SGS 9 -01

Task Force Meeting - January 18-19, 2010

SGS-8 – January 20-22, 2010

Global technical regulation No. xx

Figure 1. Example of High-level Schematic of Key Systems in FCVs

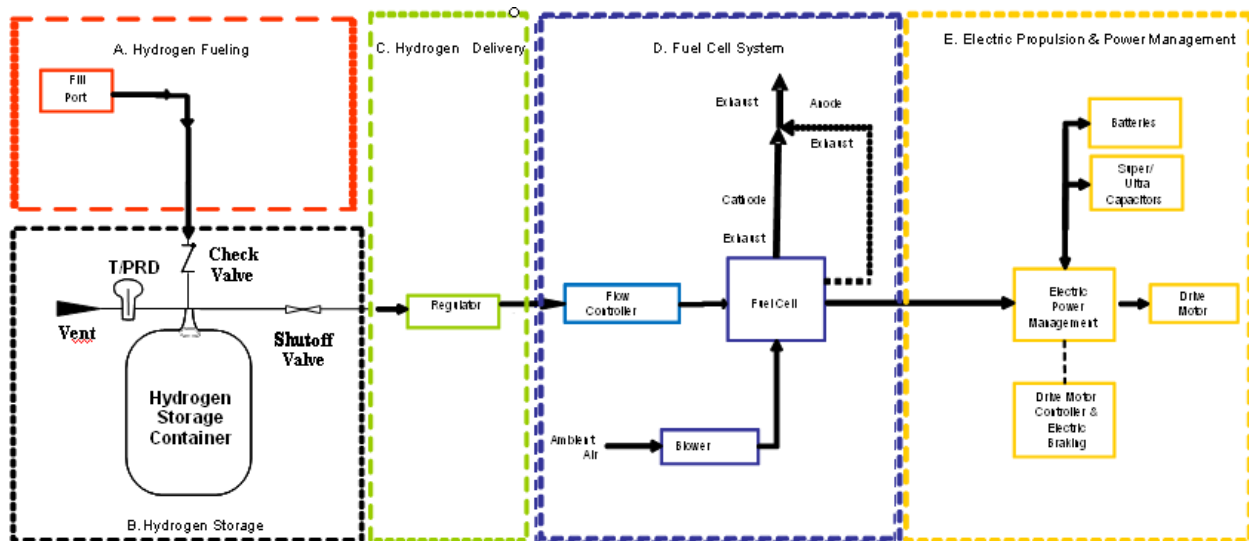
▶▶ SGS-8 OICA comment #1: In case of LH2 extraction of liquid hydrogen should be also allowed. According to Figure 4 the coolant heat exchanger does not contain to the LH2 storage system.

- SGS-8 increase text size

DRAFT**Figure 2. Example of a Fuel Cell Vehicle****3.2 HYDROGEN FUELING SYSTEM**

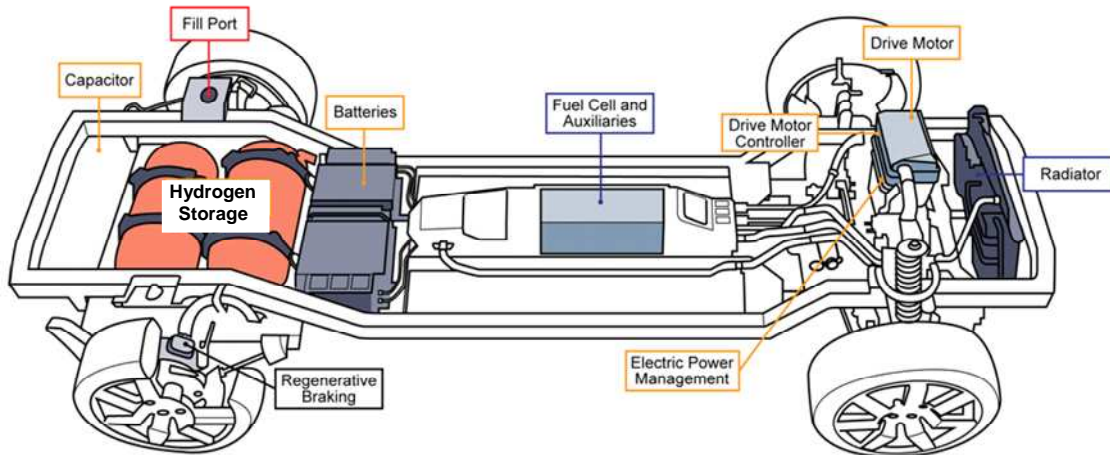
▶▶ SGS-8 OICA comment #2: captured in yellow text.

Figure 4. Typical Liquefied Hydrogen Storage System

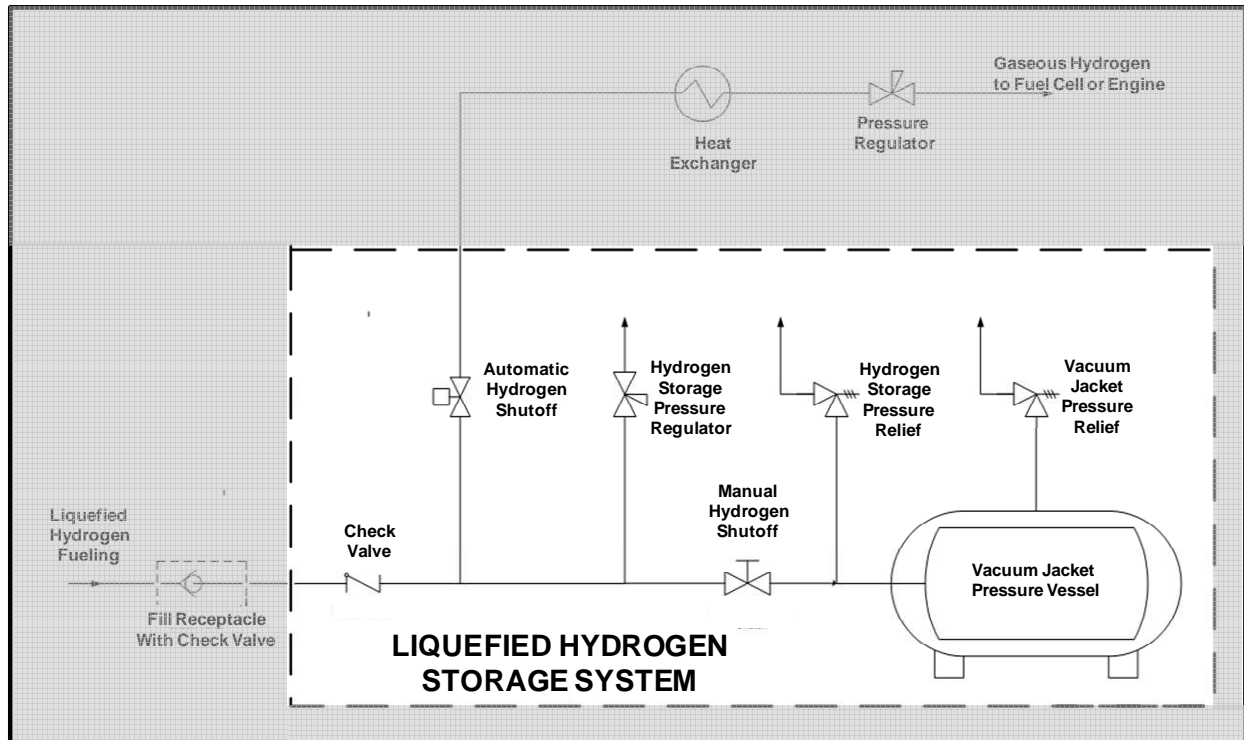
▶▶ *SGS-8 OICA(BMW) comment #7 – proposed text revisions highlighted in 3.3.2 text -- except proposal for deletion of check valve -- SGS discussion is required -- also except Fig 4 (but content of figure change is included in GWS comment #7 figure)*

▶▶ *SGS-8 GWS comment #7: text proposal of similar content to OICA #7&8 and Germany #5 (except check valve); figure revision proposed*

↪ *SGS-8 Germany comment #6: move a PRV to downstream of shut-off valve in figure*
-- text & figure accommodate Germany comments

▶▶ SGS-8 OICA comment #1: According to Figure 4 the coolant heat exchanger does not contain to the LH2 storage system.

Figure B.5.1.1 Generic Hydrogen Storage System

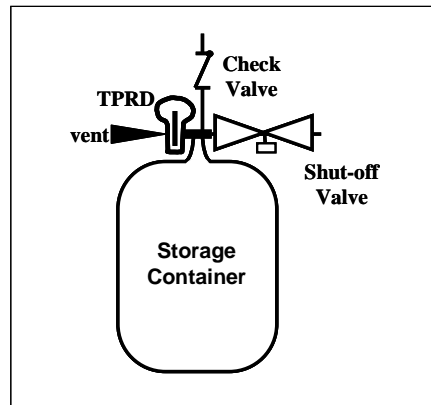
B.5.1 This section specifies the requirements for the integrity of the compressed hydrogen storage system. As illustrated in Figure B.5.1.1, the hydrogen storage system consists of the high pressure storage container(s) and closures of openings into the high pressure storage container(s). Closures include the temperature-activated pressure relief device(s) (TPRD), check valve(s), shut-off valve(s) and all components, fittings and fuel lines that isolate the high pressure storage system from the remainder of the fuel system and environment. **The check valve, shut-off valve and TPRD(s) shall be mounted directly on or within each container.**

TFG – agreement with Japan’s proposal.

SGS-8: OICA raised reservation. The rationale will be provided in part A.

Figure B. 5.1.2 Verification Test for Performance Durability (hydraulic)

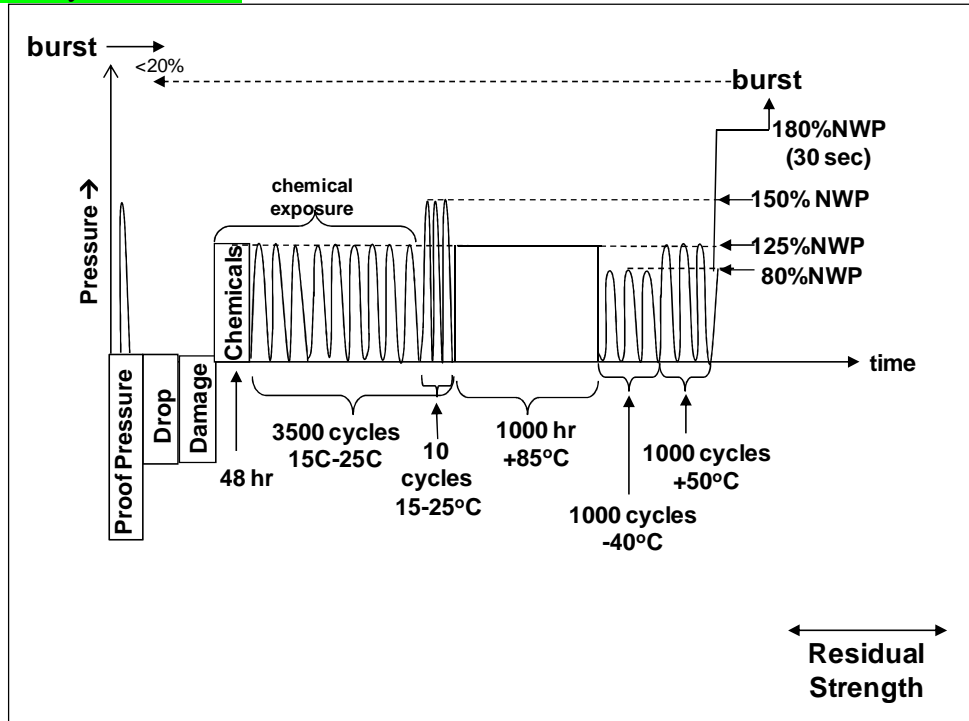
SGS-8 ISO comment #12: A boss torque test should be included for composite tanks with non load sharing liners.

TFC – change the last 1000 cycles to 85C.

TFG – OICA will provide a rationale in part A for not including the boss torque requirement. Need to address the leakage up stream of the shut-off valve.

SGS-8: Not include boss torque test in part B. OICA will provide rationale in part A. Japan raises a study reservation.
